# Performance Bulletin

September 2007

## Motor Changes for 9000, 9100, & 9500 Valves

**New Assembly  
(Motor, Ground Plate, & Label)**

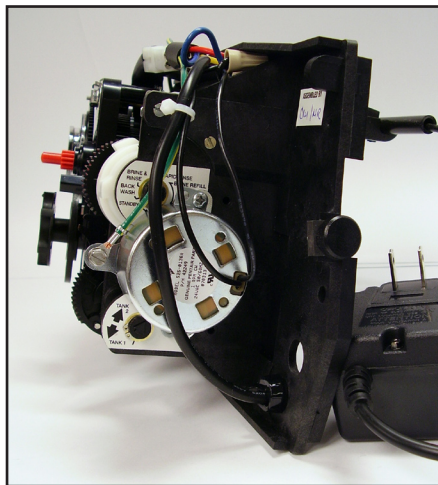
Effective immediately as a running change, there will be new 120V and 220V motors for the 9000/9100/9500 valves. The new motors will be 4 watt (the previous ones were 2.7 watt), and boast all-metal gear trains. The labels and grounding plates will change to facilitate the new motors. Additionally, an instruction sheet will be included with the service kit.
